Change Record

Contract Number 008952	Contract Title I-5, NB MLK Jr Way to NE Ravenna Bridge, Pavement Repair & More	Federal Aid Number HSIP-0053(974)
Change Order Number 28	Change Description Segment 1 Friction Grinding	Date Sep 25, 2019
Region Northwest Region	Project Engineer <i>EX-</i> Edward W. Kane, P.E.	Phone Number 425-225-8725

CONTRACT NO: 008952 FEDERAL AID NO: HSIP-0053 (974)  
CONTRACT TITLE: DESIGN BUILD I-5, NB MLK JR WAY TO NE RAVENNA BRID  
CHANGE ORDER NO: 28 SEGMENT 1 FRICTION GRINDING

Contract 8952  
 Date 9/11/2019  
 Change Order #28  
 Sheet 4 of 5

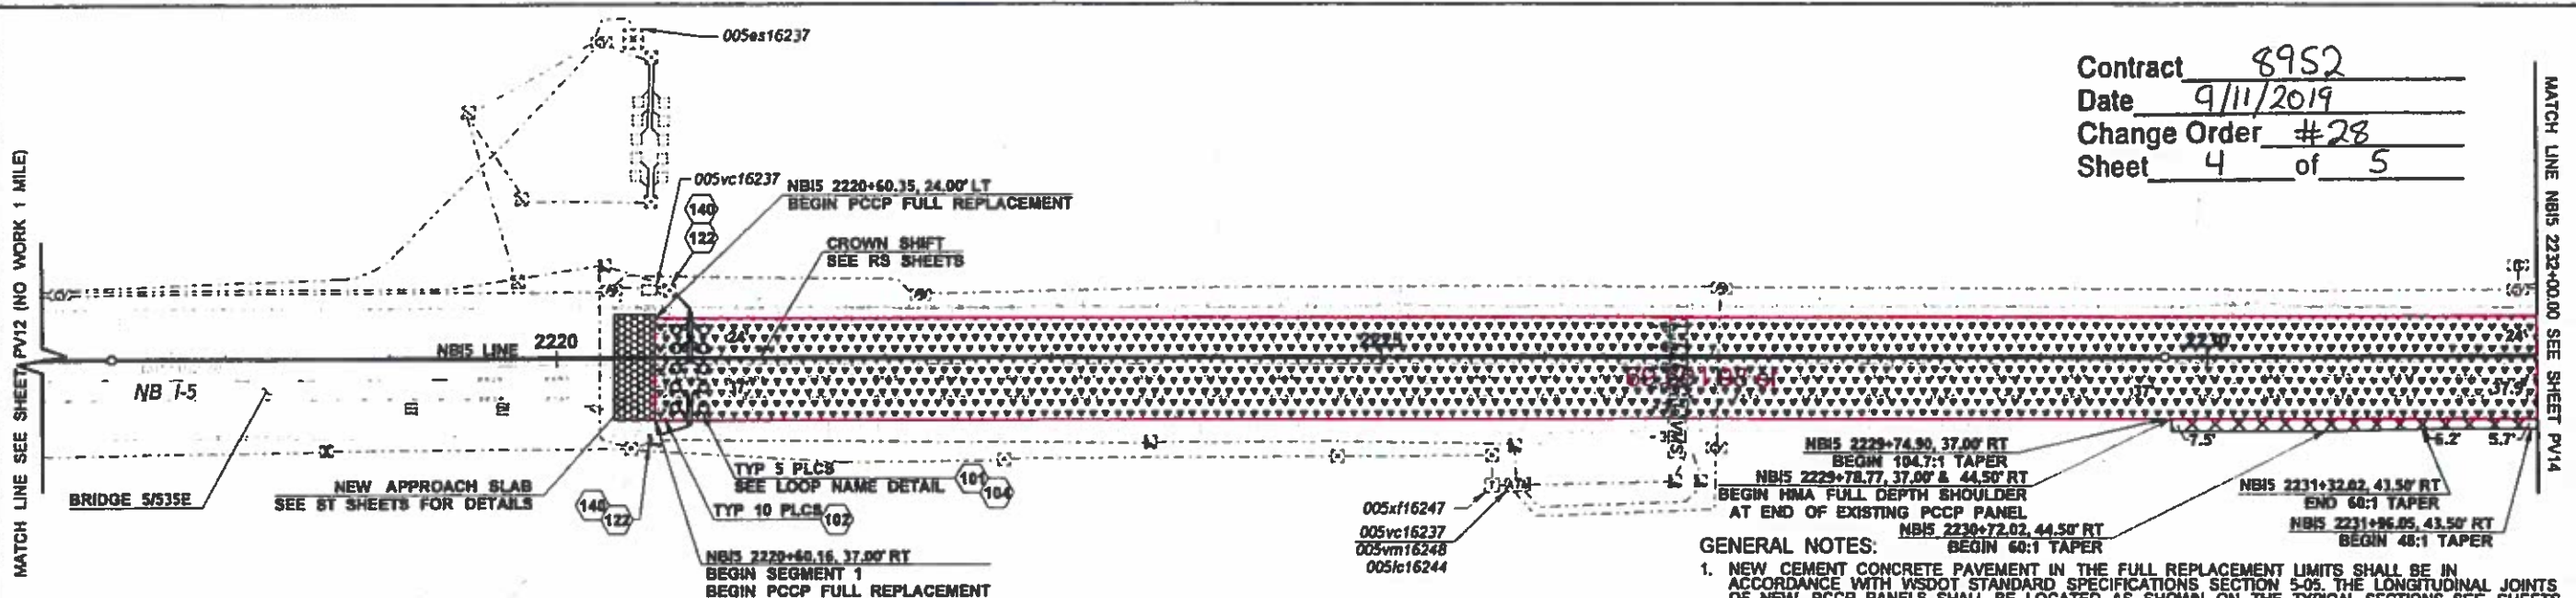
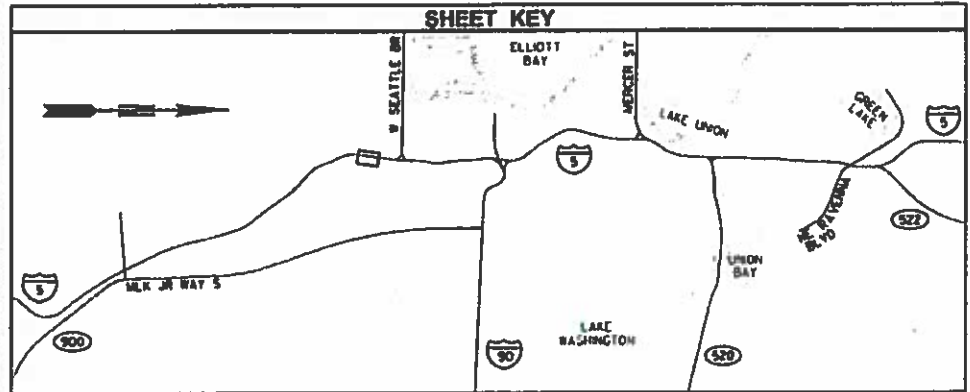
The Design-Builder shall grind PCCP to remove all existing surface texturing in the areas shown on Pages 4 and 5 of this change order.
